Rhode Island Turnpike and Bridge Authority
P.O. Box 437 | Jamestown, Rhode Island 02835-0437

May 14, 2025

ADDENDUM NO. 04
Invitation for Bids – 24-03R

Mount Hope Bridge Overlay Replacement

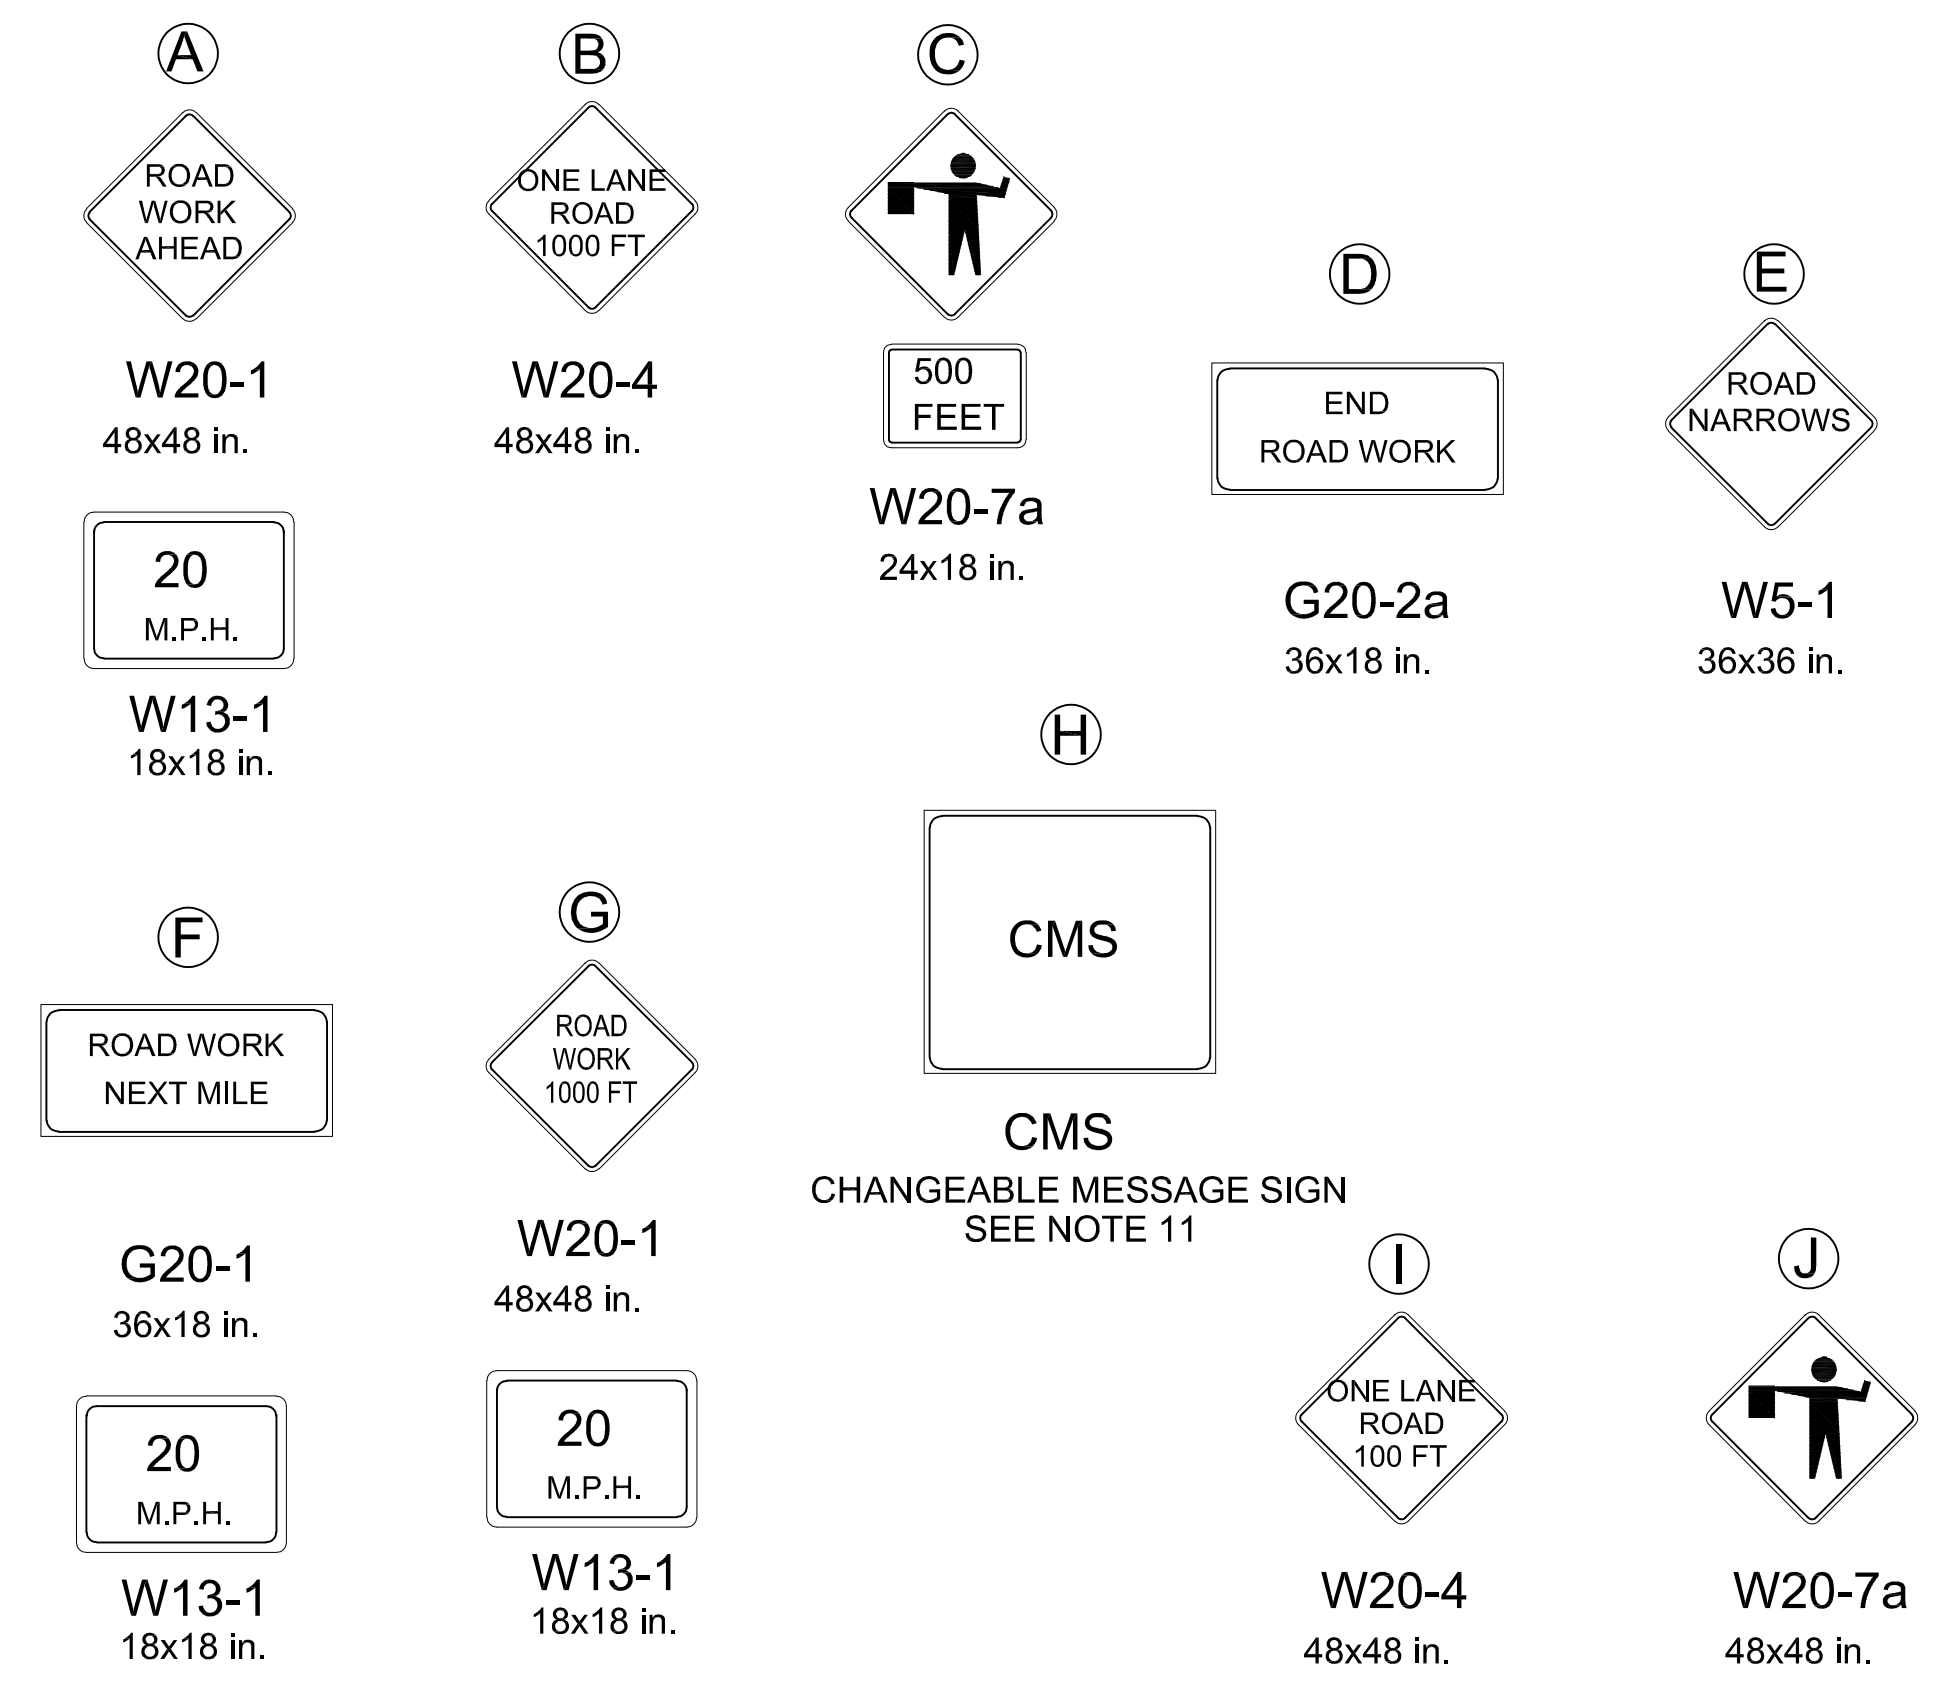
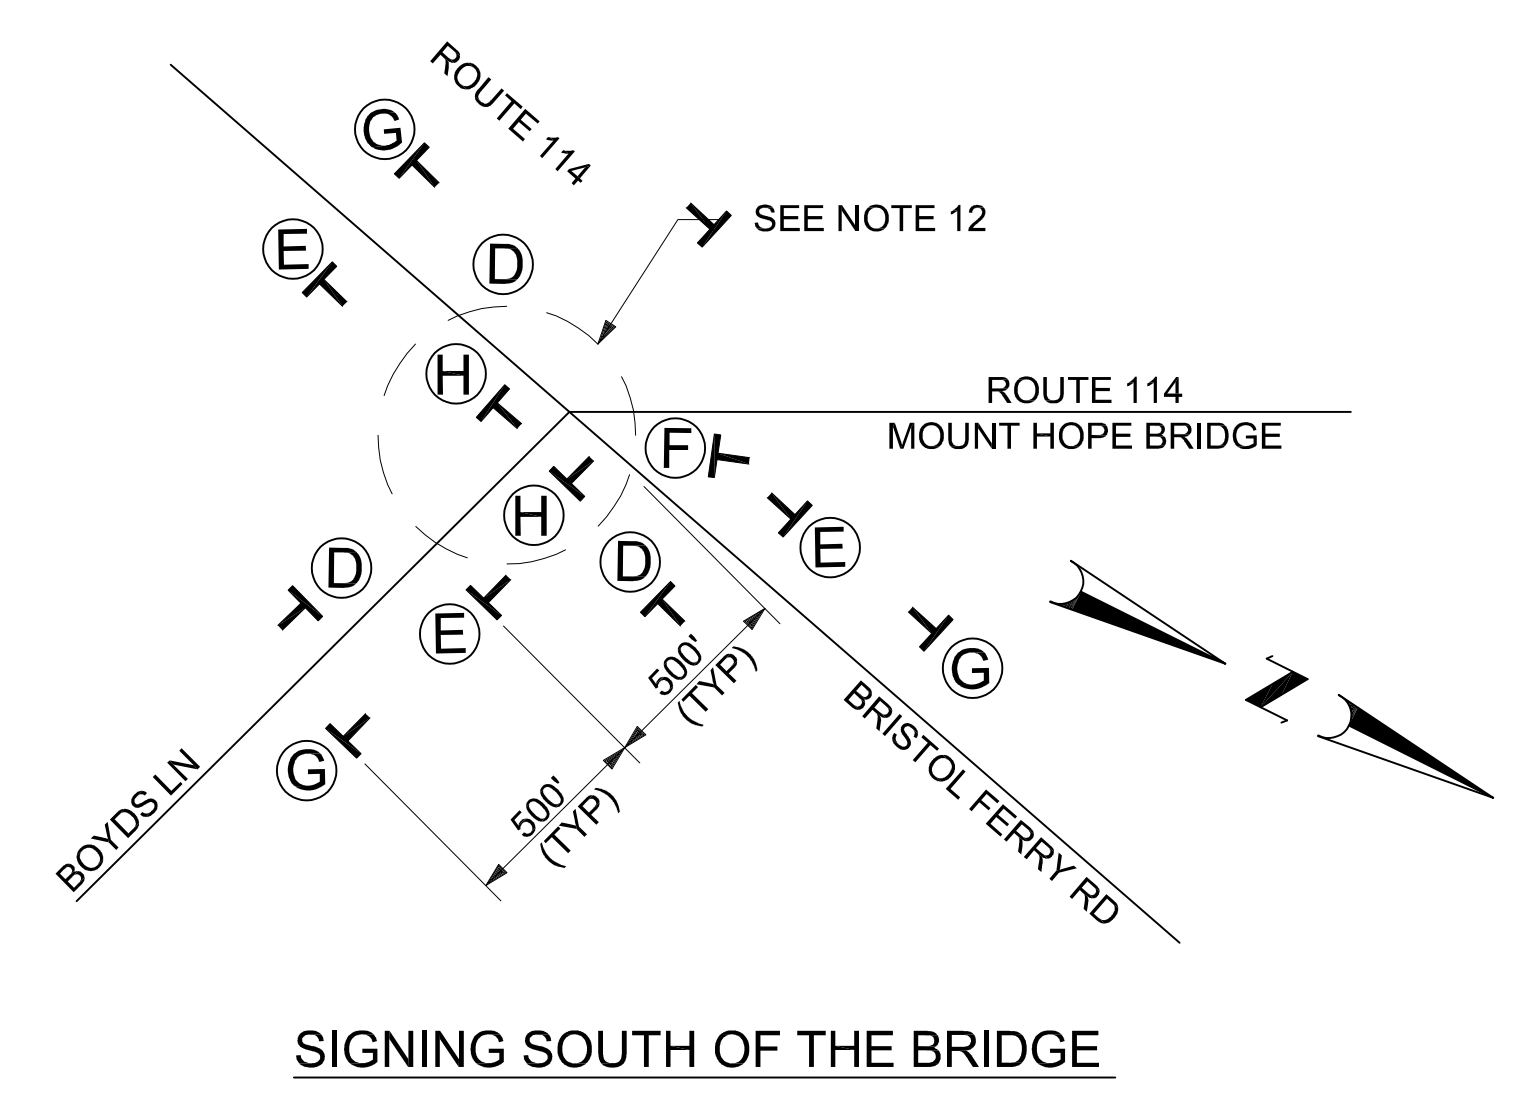
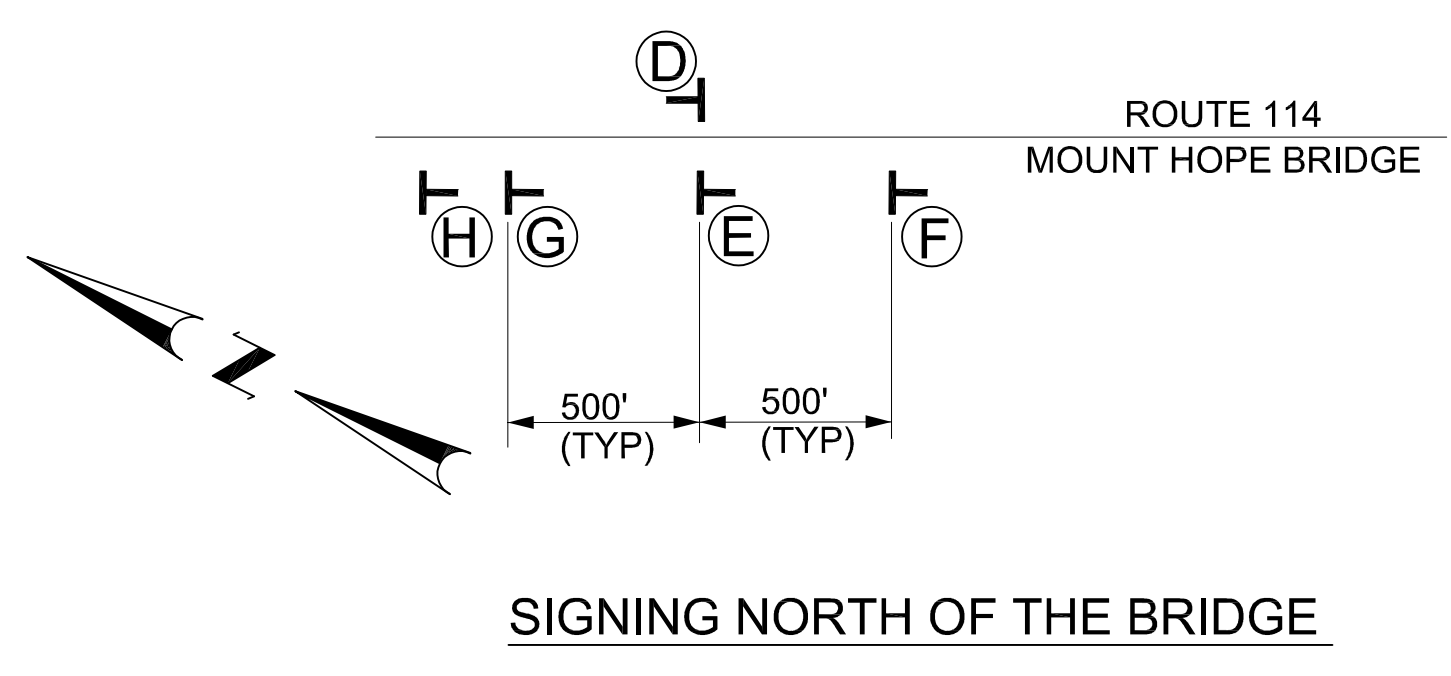
1. **REPLACE** Contract Drawing Sheet 7. Sheet 7 was revised to modify the weekend lane closure operation window.

- CONTINUOUS WEEKEND DAYTIME AND NIGHT TIME LANE CLOSURE OPERATIONS SHALL BE PERMITTED. WEEKEND LANE CLOSURE OPERATIONS, INCLUDING SET UP AND PICK UP SHALL BEGIN NO EARLIER THAN 7:00 PM FRIDAY AND LANES SHALL BE RESTORED BY 5:00 AM MONDAY.
